UNITED STATES
NUCLEAR REGULATORY COMMISSION
WASHINGTON, D. C. 20555

APPLICANT: Public Service Electric & Gas Company (PSE&G)
FACILITY: Hope Creek Generating Station
SUBJECT: SUMMARY OF STRUCTURAL AND GEOTECHNICAL ENGINEERING
BRANCH (SGEB) MEETING

On August 1, 1984, a meeting was held in the Bethesda, Maryland offices of the NRC to discuss the remaining SGEB-Structural audit open items identified in the Draft SER. A list of meeting attendees is included as Enclosure 1 to this meeting summary.

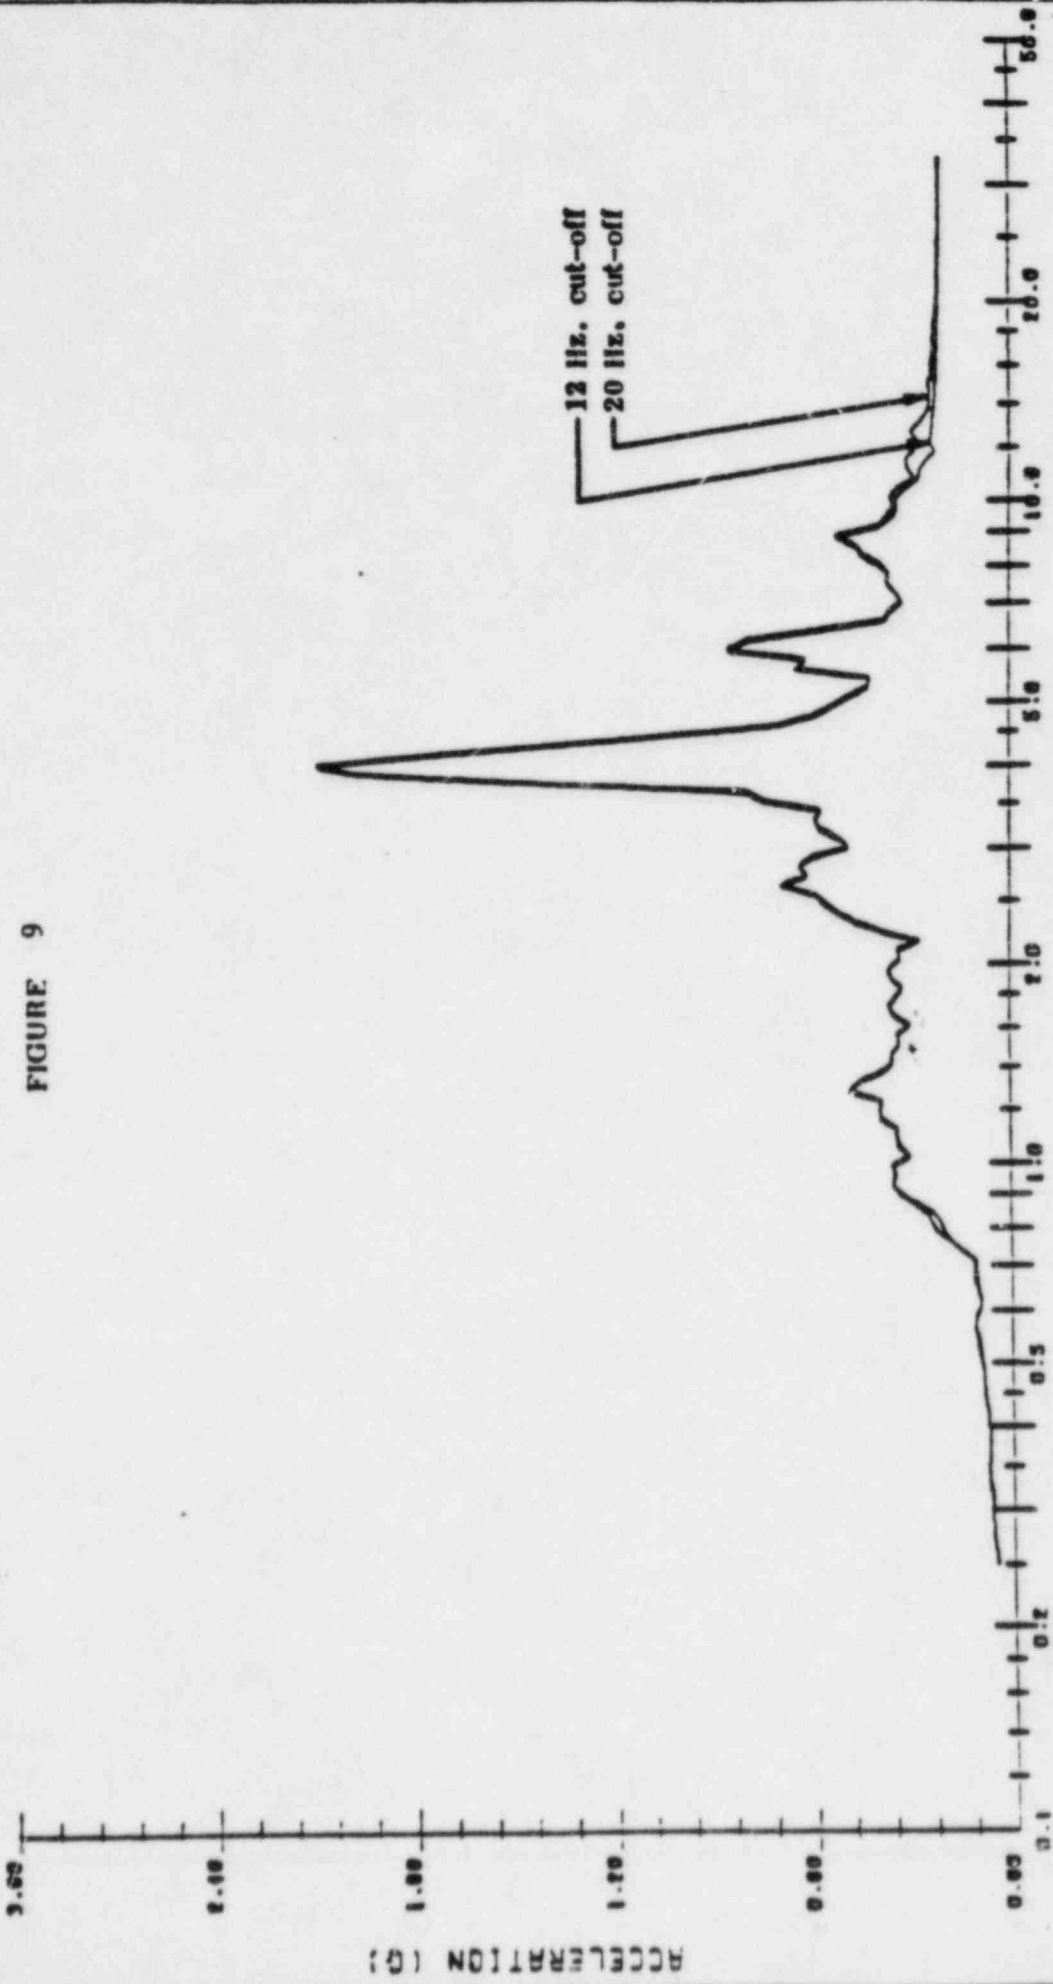
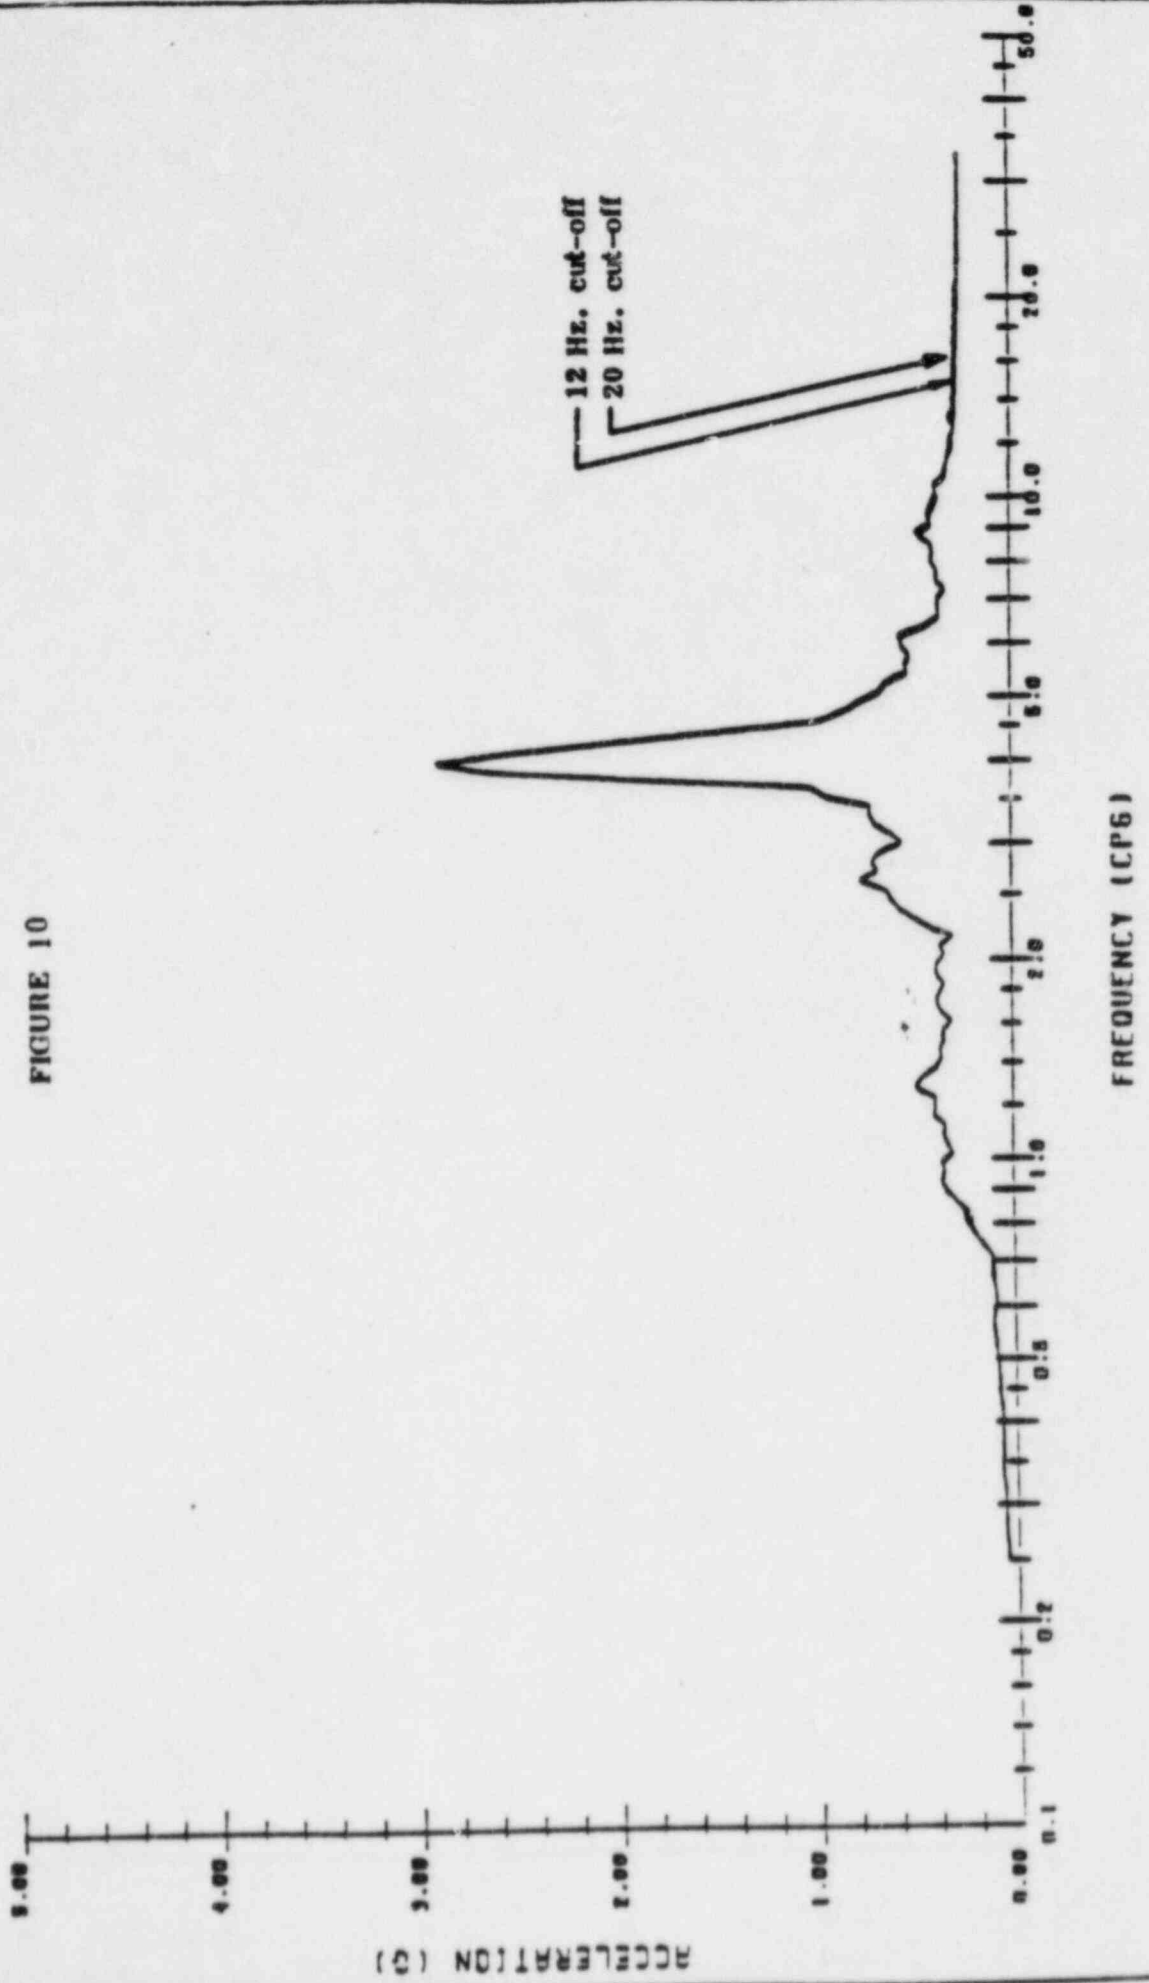
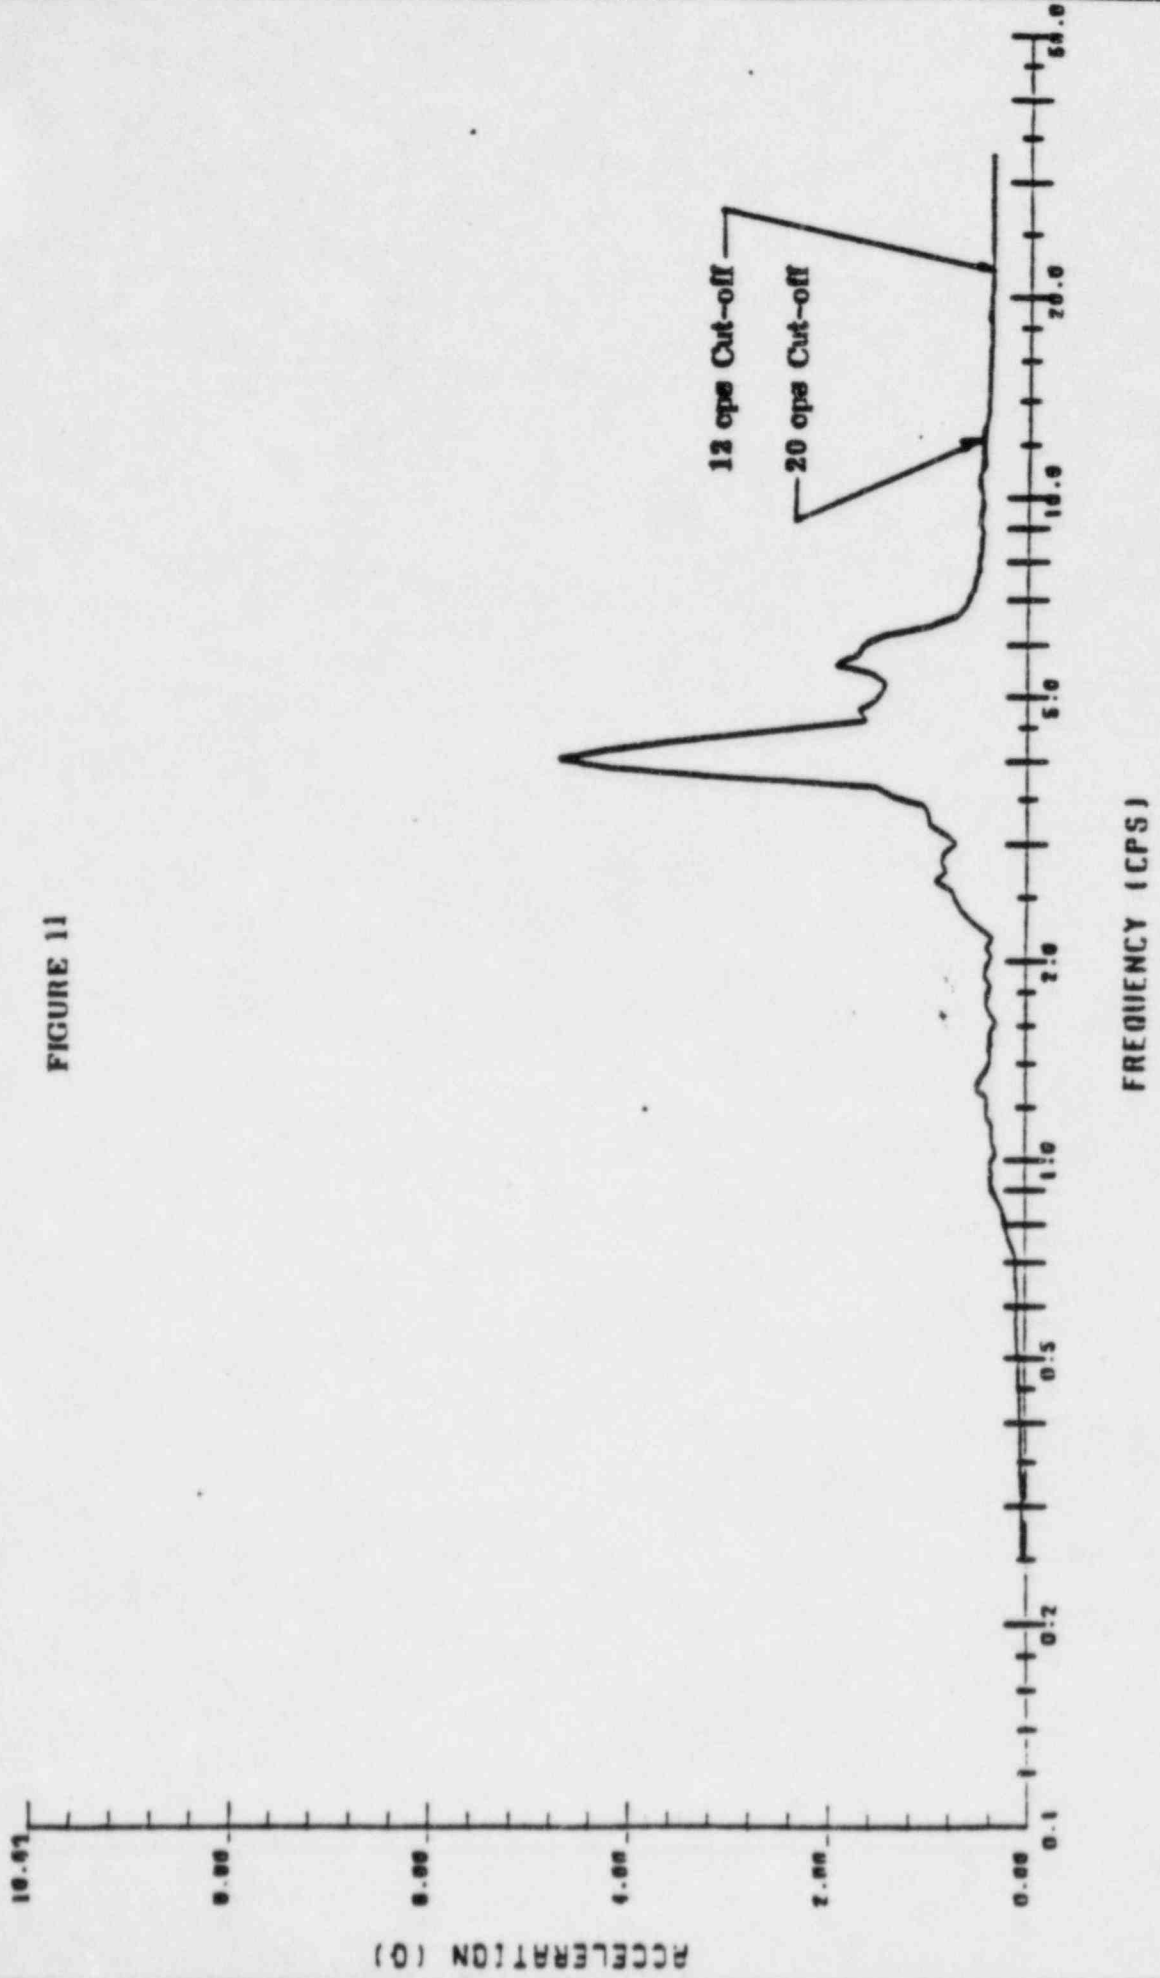
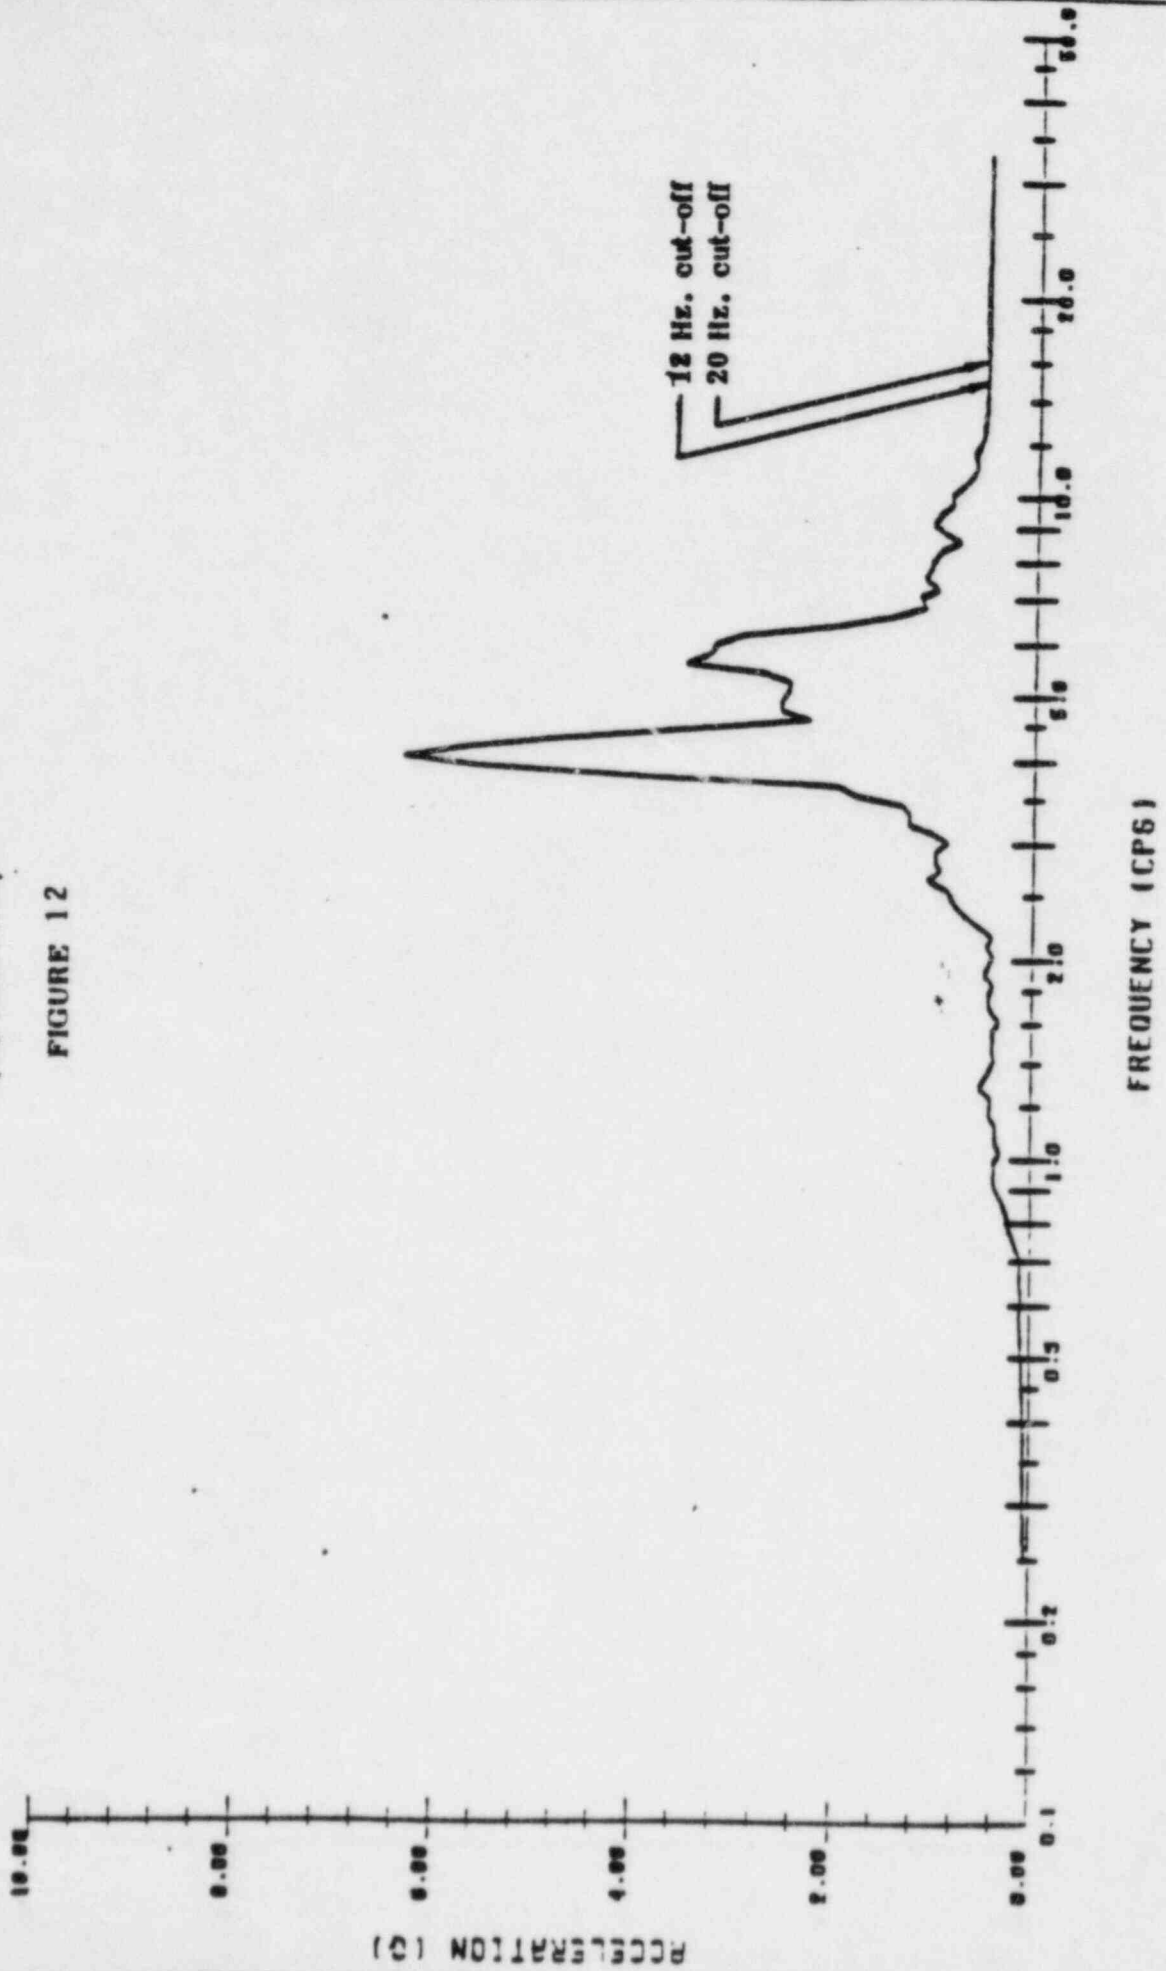
QUESTION: Justify the 12 Hz. cut-off frequency for SSI analysis.

Response spectra plots at various elevations of the Reactor Building are presented in Figure 9 through 12. As can be seen from these figures, the spectral accelerations in the low and mid frequency range are essentially identical for the two cut-off frequencies. In the frequency range above 12 Hz., there are minor differences at the lower elevations of the Reactor Building, but almost no variation in the upper elevations. However, these minor differences are considered to have no significance on global structural response. For all elevations, the overall trend of the curves is identical, duplicating peak response values and shape of the spectral curves.
